Sams Attire Ltd. (Extension)

Bhuiyan Tower, Plot #10, Jamgora, Ashulia Road, Saver, Dhaka, Bangladesh

20th August 2019

Observations

Exposed rebars on roof slab.

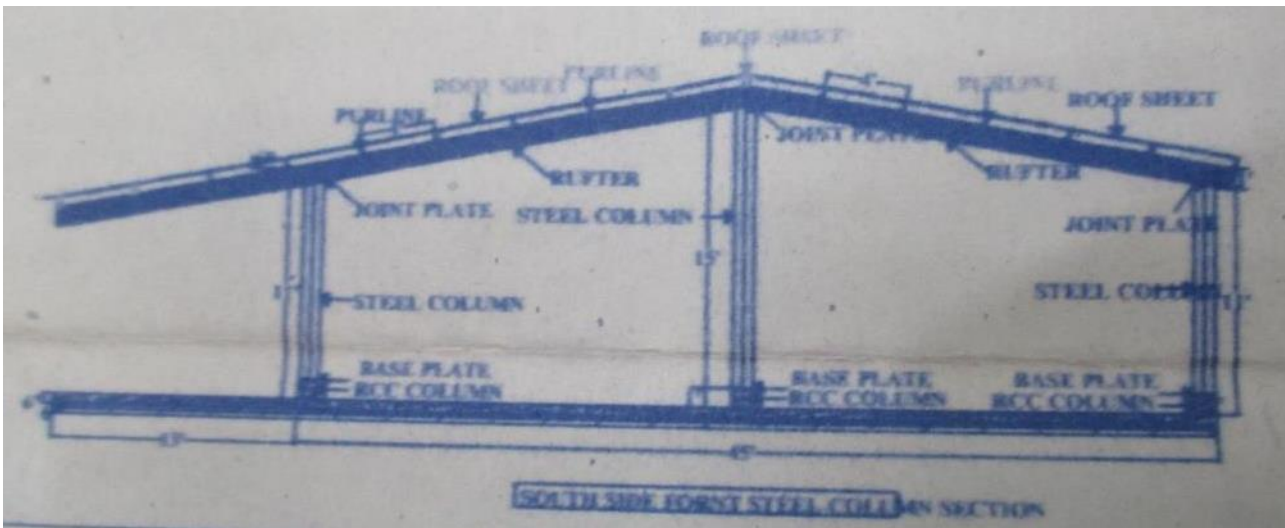
Exposed rebar was found on roof. Factory engineer is required to take necessary steps to protect the rebars from corrosion.

| Item No. | Observation | Recommended Action Plan | Recommended Timeline |
|----------|---|---|----------------------|
| 5 | Exposed rebar on roof (Building-2) | Apply corrosion resistance paint to the exposed rebars. | 6-weeks |

Observations: Shed-5

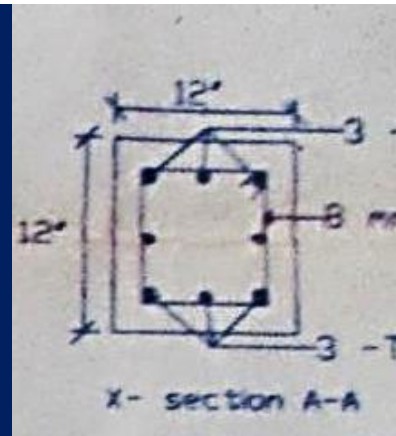
8 rebar was shown in RC column where 4 rebar was found by ferro scanning. Also, column size was found 250 mm instead 300 mm.

A set of permit layout drawings was provided where detail drawings not available. Also, the reinforced concrete column size and rebar detail does not match with on site. The factory engineer is required to survey the structure and prepare a full set of as-built drawings.

| Item No. | Observation | Recommended Action Plan | Recommended Timeline |
|----------|---|---|----------------------|
| 6 | Insufficient as-built drawing (Shed-5) | The factory engineer is required to survey the structure, collect information and produce as-built architectural and structural documentations. | 6-weeks |

Lateral stability system

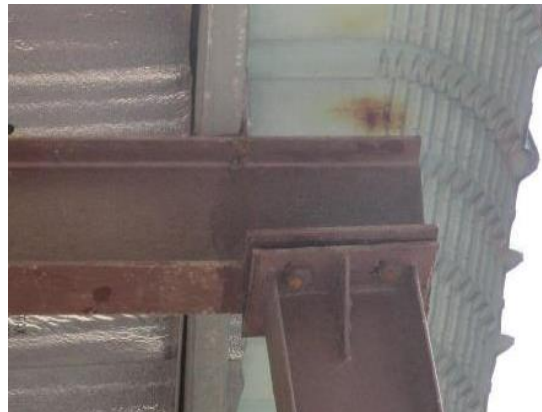
No compression strut and bracing at roof

Gap in RC column-steel rafter connection

Significant gap between joint plates and support

No compression strut and bracing was observed at roof level. Also, connection gap between joint plates of column and rafter was observed in several locations. The factory engineer is required to verify the lateral stability system of the shed.

| Item No. | Observation | Recommended Action Plan | Recommended Timeline |
|----------|---|---|----------------------|
| 7 | Lateral stability system (Shed-5) | Carry out an engineering assessment to verify the lateral stability of the structure. | 6-weeks |
| 8 | Lateral stability system (Shed-5) | Building engineering is required to carry out repair works on the significant gaps. | 6-weeks |
| 9 | Lateral stability system (Shed-5) | Carry out remedial works as outcome of engineering assessment report. | 6-months |
